ADDENDUM No. 3

MBWWTP SOLIDS PROCESS OPTIMIZATION IMPLEMENTATION PHASE 2 THICKENER UPGRADES CONTRACT NUMBER W-16-017-201

CITY OF CHATTANOOGA, TENNESSEE

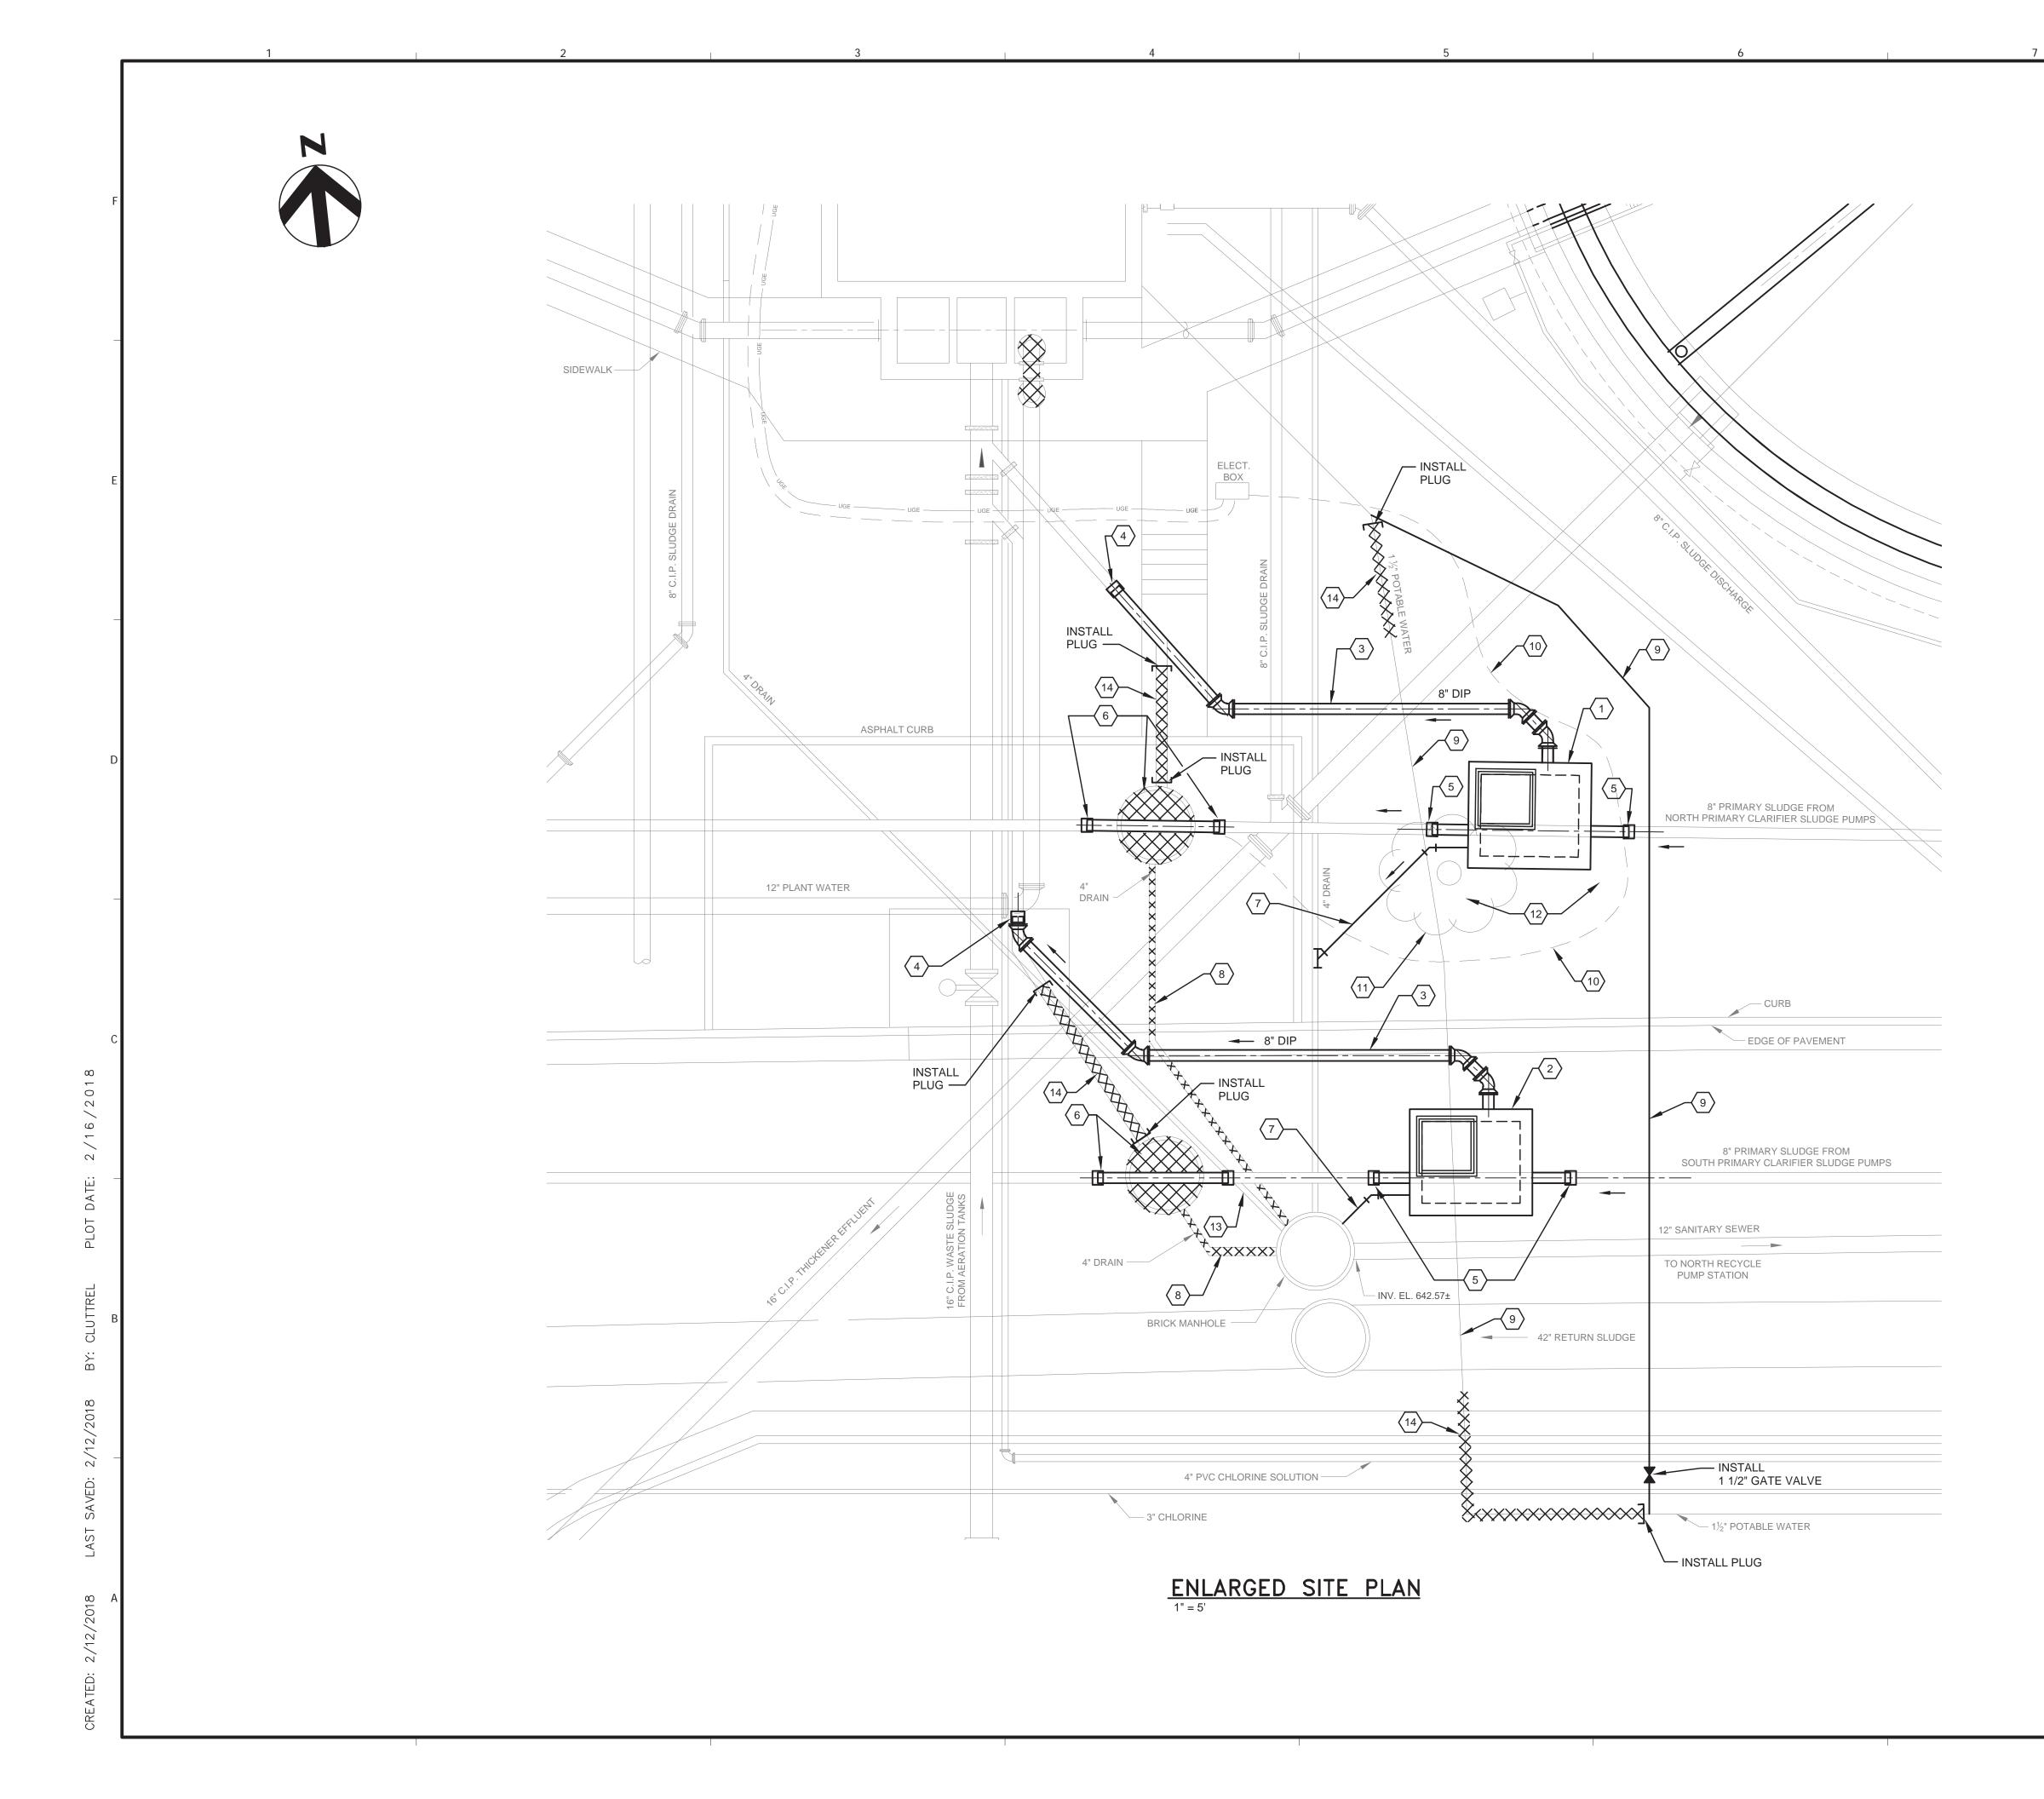
Replace drawing 01C-02 with the attached revised drawing. The scale of this drawing is now set to $1^{"} = 5$ '. No other changes were made.
